WAIHI ACCESSIBILITY AUDIT REPORT

CCS DISABILITY ACTION

DECEMBER 2014

Hauraki District Council (HDC) has requested an accessibility audit for the Central Business District (CBD) area of Waihi, with particular emphasis for disabled and elderly residents. The audit covers:

Figure 9: Mobility Space with blue surfacing design

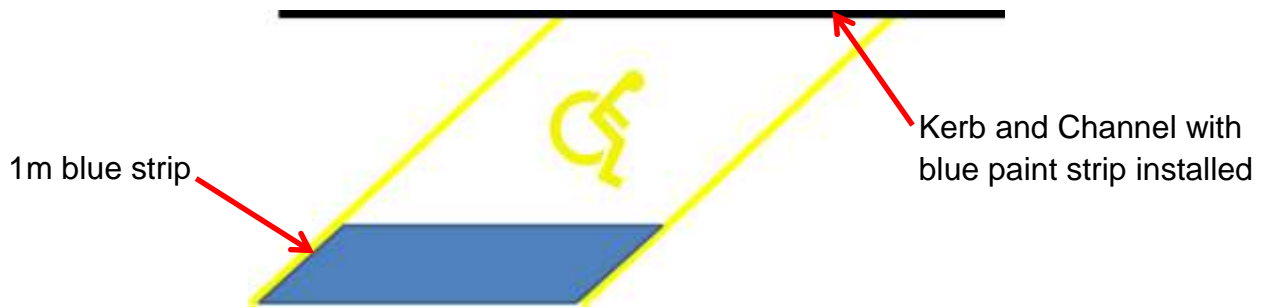
While full blue coverage is preferred for marking mobility parking spaces, in the interest of maintenance and costs, consideration could be given to only partially colouring the mobility space as shown in Figure 9.

A 1m strip for the length of the road edge of the carpark will provide visual notice to road users, reduce installation costs, and reduce the need for repair when replacing kerb and channel etc.

Recommendation 13 Install blue marking as per figure 9 will aid with maintaining a non-slip surface with the colour of both the surface and the marking to comply with Land Transport Rule: Traffic Control Devices 2004.

Figure 17: Preferred Layout of crossing points with Tactile Paving

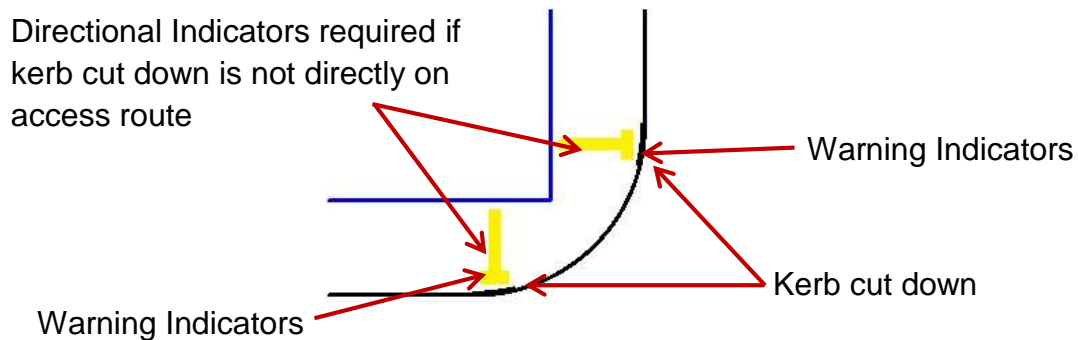
Where required, Directional Indicators shall be installed in conjunction with warning indicators where a road crossing point is not located in the continuous accessible path of travel and directional guidance is required.

Where required, Directional Indicators shall be installed³⁷:

- In conjunction with Warning Indicators where a road crossing point is not located in the continuous accessible path of travel and directional guidance is required; and
- Across the full width of the path, with a minimum depth of 600mm to indicate a change in direction of the continuous accessible path of travel.

Figure 22: Power Pole outside Countdown on SH.2

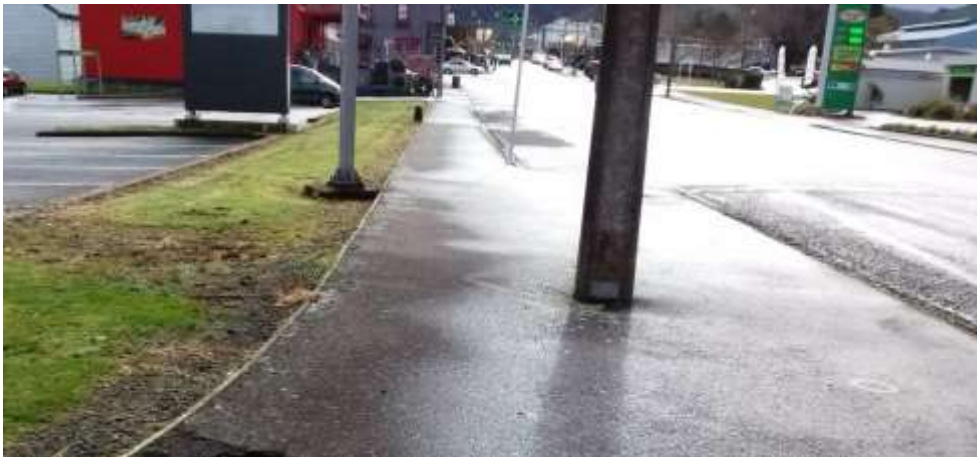
Similarly, a power pole outside Countdown on SH.2 is in the middle of the footpath. This can create a hazard for visually impaired users and young children. A long term solution would be to request Powerco to re-locate the power pole to the rear of the footpath. A short term solution is to highlight the pole by painting the first two metres in yellow.

Recommendation 40 Highlight the sign footing at the Mobil Service Station and the power pole outside Countdown on SH.2 in yellow to aid visually impaired users navigate these locations.
